Planning and Development (Technical Amendment—Miscellaneous Amendment) Plan Variation 2015 (No 2)*

Notifiable Instrument NI2015—471

Technical Amendment No 2015-06

Code, clarification and relocation amendments to the single dwelling and multi unit housing development codes and various precinct codes

Figure 5: Active frontages and main pedestrian areas and routes

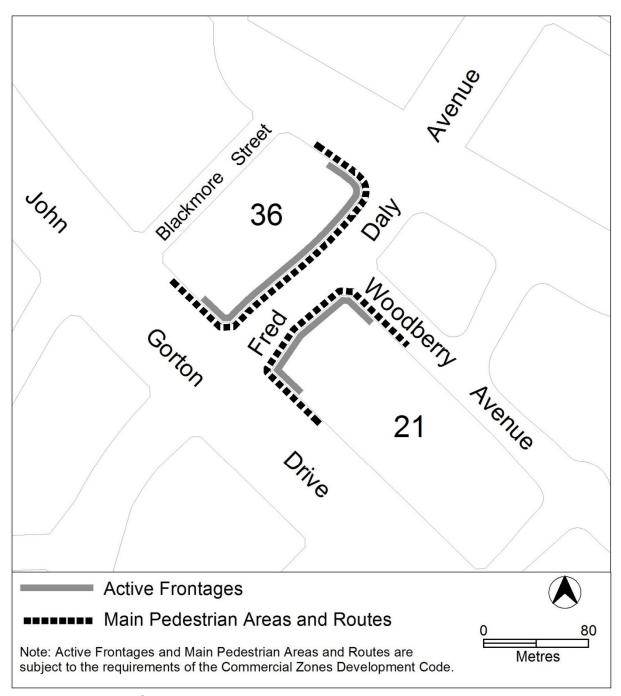
In addition, Figure 4 of the concept plan shows the intersections and associated corners with John Gorton Drive and other roads within the CZ4 and CZ5 zones (including Fred Daly Avenue) as requiring a 'Shop Frontage' and an 'Urban Streetscape'. This would be considered as 'active frontages' and 'main pedestrian routes' respectively under the requirements of the commercial zones development code. It is proposed to include a figure identifying this in the precinct code to clarify that these areas are considered 'active frontages' and 'main pedestrian areas and routes' for the purposes of R50 and C50 of the commercial zones development code.

This rule applies to Figure 5.

Areas identified as 'active frontages' and 'main pedestrian areas and routes' comply with the applicable provisions in the commercial zones development code.

Section	Statement
s87(i) a variation to relocate a provision within the territory plan if the substance of the provision is not changed	Compliant. This amendment relocates relevant provisions from the Coombs and Wright concept plan to the Coombs precinct code as the content of the provision is still relevant to proposed development on land in the CZ4 and CZ5 zones. The substance of the provisions has not been changed.

Figure 4 – Active frontages and main pedestrian areas and routes

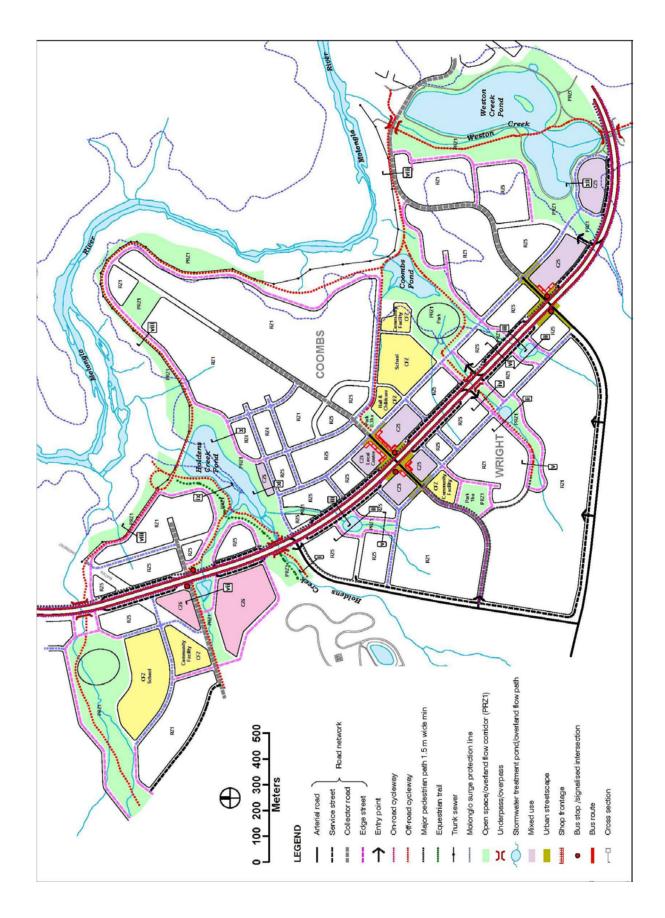
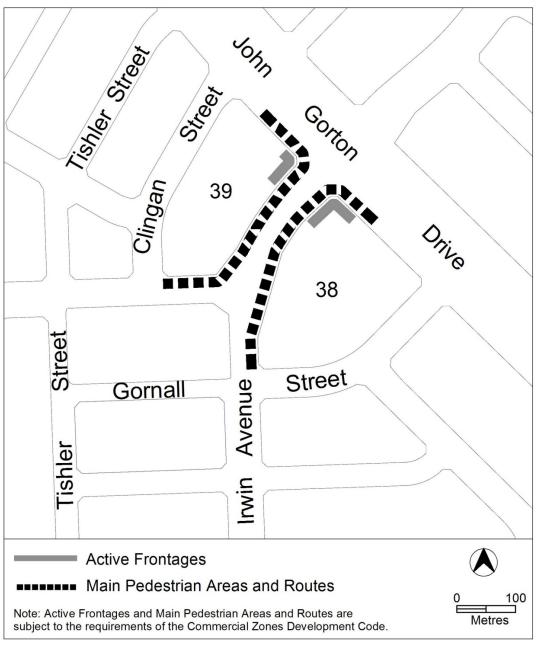
Figure 4 of the concept plan shows the intersections and associated corners with John Gorton Drive and Steve Irwin Avenue in the CZ5 zone as requiring a 'Shop Frontage' and an 'Urban Streetscape'. This would be considered as 'active frontages' and 'main pedestrian areas and routes' respectively under the requirements of the commercial zones development code. It is proposed to identify this in the precinct code by including a figure in the RC2 – Mixed use area, with minor amendments to the terminology to clarify that these areas are 'active frontages' and 'main pedestrian areas and routes' for the purposes of R50 and C50 of the commercial zones development code.

Rules	Criteria	
5.3 Active frontages and main pedestrian areas		
R9		
This rule applies to Figure 4. Areas identified as 'active frontages' and 'main pedestrian areas and routes' comply with the applicable provisions in the commercial zones development code.	This is a mandatory requirement. There is no applicable criterion.

Section	Statement
s87(i) a variation to relocate a provision	Compliant. This amendment relocates
within the territory plan if the substance	relevant provisions from the Coombs and
of the provision is not changed	Wright concept plan to the Wright
and:	precinct code as the content of the
s87(h) a variation to clarify the language	provision is still relevant to proposed
in the territory plan if it does not change	development on land in the CZ5 zones.
the substance of the plan.	The substance of the provisions has not
	been changed.

Figure 5: Active frontages and main pedestrian areas and routes

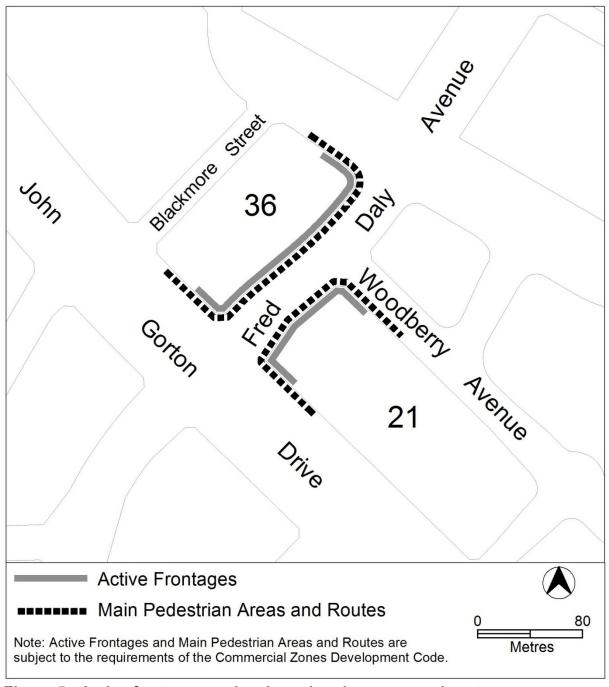
This rule applies to Figure 5.

Areas identified as 'active frontages' and 'main pedestrian areas and routes' comply with the applicable provisions in the commercial zones development code.

Figure 4 – Active frontages and main pedestrian areas and routes

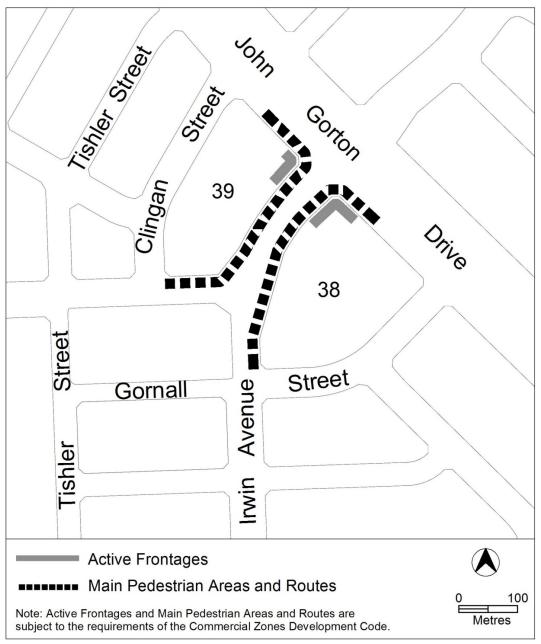
Insert after Rule R8

Rules	Criteria
5.3 Active frontages and main pedestrian areas	
R9	
This rule applies to Figure 4. Areas identified as 'active frontages' and 'main pedestrian areas and routes' comply with the applicable provisions in the commercial zones development code.	This is a mandatory requirement. There is no applicable criterion.
